Additional Information with respect
to the development at Lands at
Forest Road, Swords, Co. Dublin

ADDITIONAL INFORMATION

Condition 9 of Reg Ref: LRD0057/S3E

Client: Golden Port Homes Limited

Landscape Masterplan

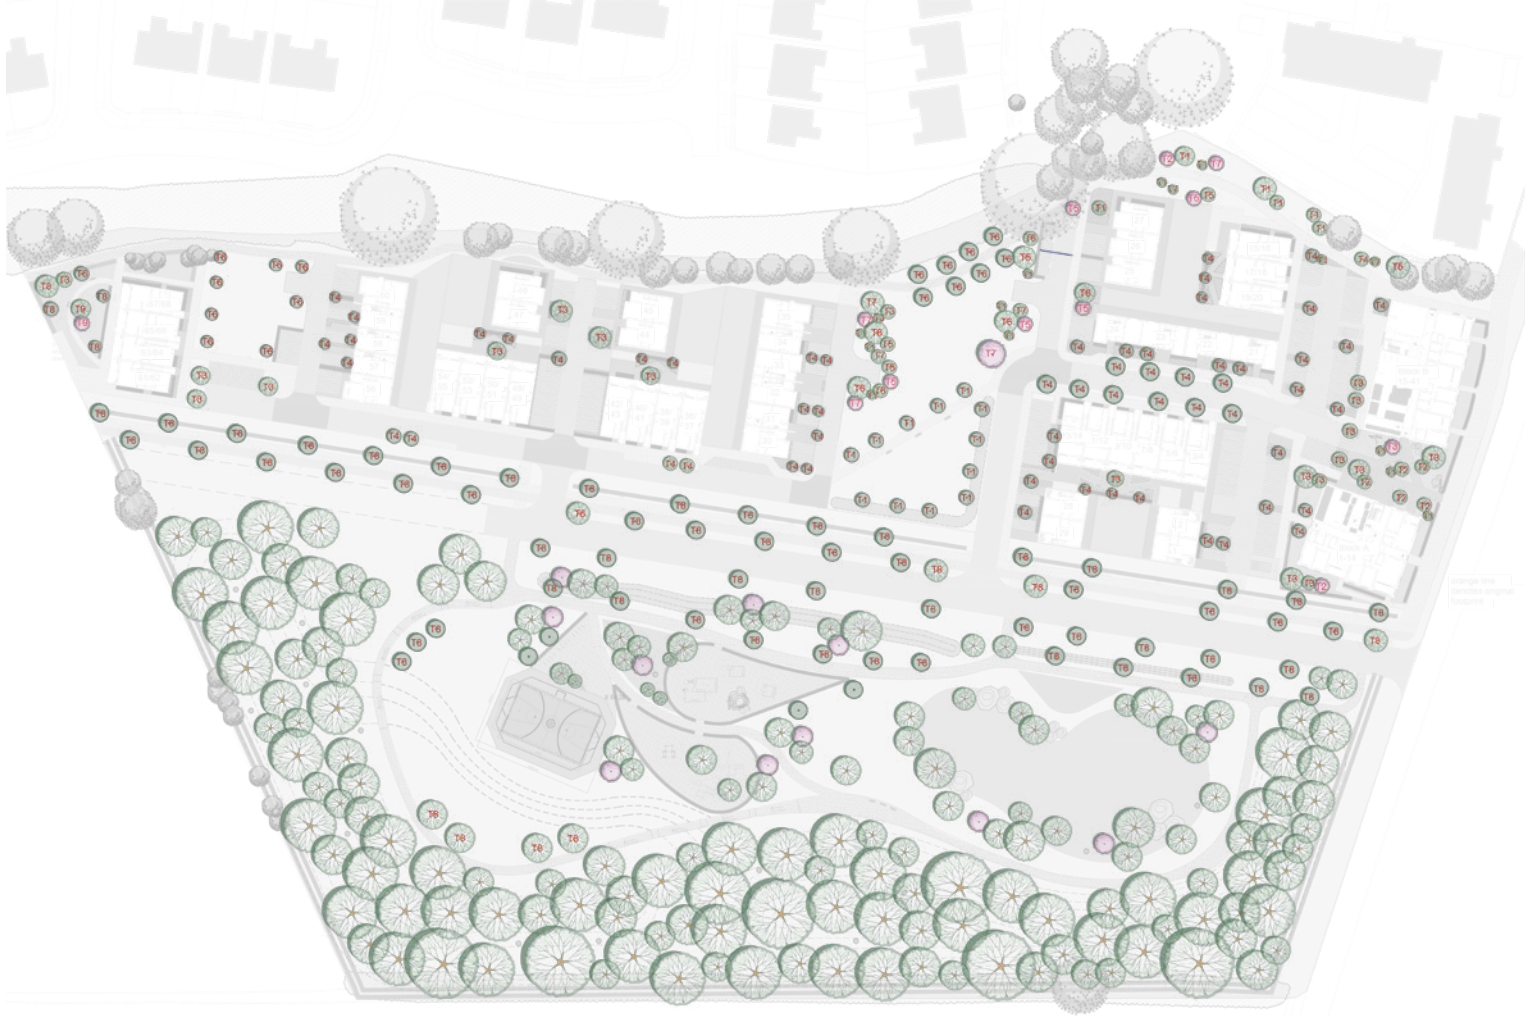
- c) Revised planting plan- Due to the strengthened restrictions of importing Oak trees (S.I.30 of 2020), any proposed Quercus species with a girth size greater than 8cm shall comply with S.I.30 of 2020 or be substituted for a suitable tree.
- d) Tree planting in the south of the site shall contain smaller trees to help establishment. For Example: 15% Betula pubescens, b/r, 120-150cm tall; 15% Corylus avellana, b/r, 120-150cm tall, 10% Pinus sylvestris, Salix cinerea, b/r, 120-150cm tall; r/b, 90-120cm tall; 10% Ilex aquifolium, r/b, 1.0m tall; 20% Sorbus aucuparia, b/r, 120-150cm tall

- c) We will comply with the strengthened restrictions under S.I. 30 of 2020 regarding the importation of Oak trees. Any proposed Quercus species with a girth size greater than 8cm will either comply with S.I. 30 of 2020 or be substituted with a suitable alternative species.
- d) The tree planting within the public open space located to the south of the site has been re-evaluated and replaced with the following mix: 15% Betula pubescens, b/r, 120-150cm tall; 15% Corylus avellana, b/r, 120-150cm tall; 10% Pinus sylvestris, b/r, 120-150cm tall; 10% Salix cinerea, r/b, 90-120cm tall; 10% Ilex aquifolium, r/b, 1.0m tall; and 20% Sorbus aucuparia, b/r, 120-150cm tall.

1875 - REV R - DWG 08 - Combined Landscape & Lighting Plan - Forest Road - RMDA

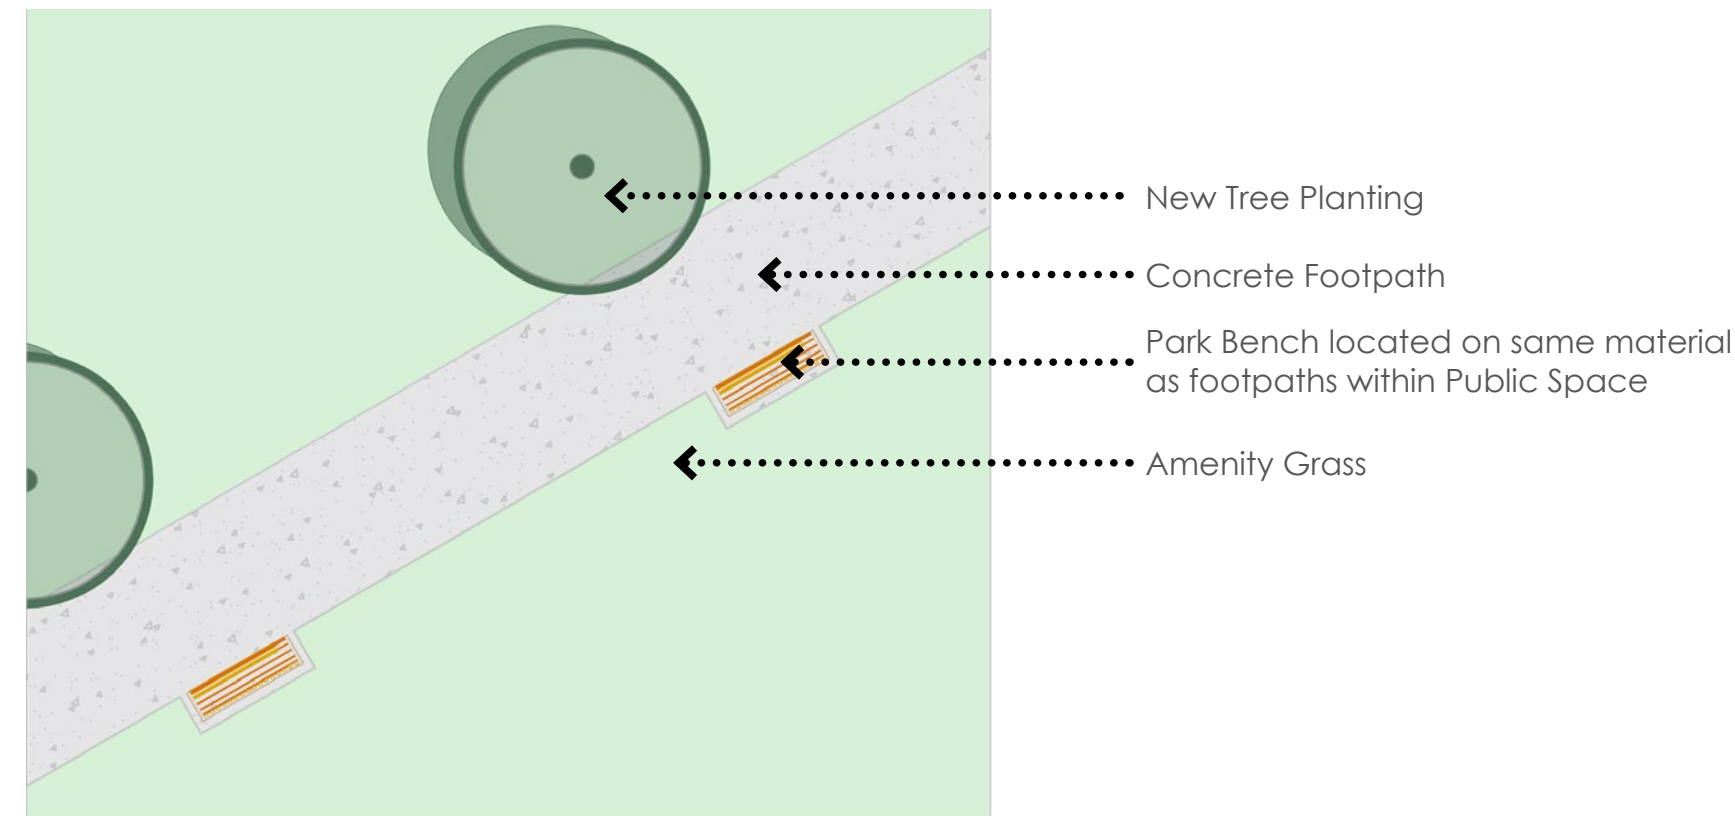
- The applicant shall submit a revised Landscape Plan which shall include the following:
- e) Lamp standards to be located on hard surface/footpaths and not on grassed areas.
 - f) Seating to be located on same material as footpaths within public open space.

e) The layout has been revised and the lamps are to be located on hard surface/footpaths and not on grassed areas. Further details, including scaled drawings, are provided in drawing:

f) Seating is located on same material as footpaths within Open Public Space. Further details, including scaled drawings, are provided in drawing:
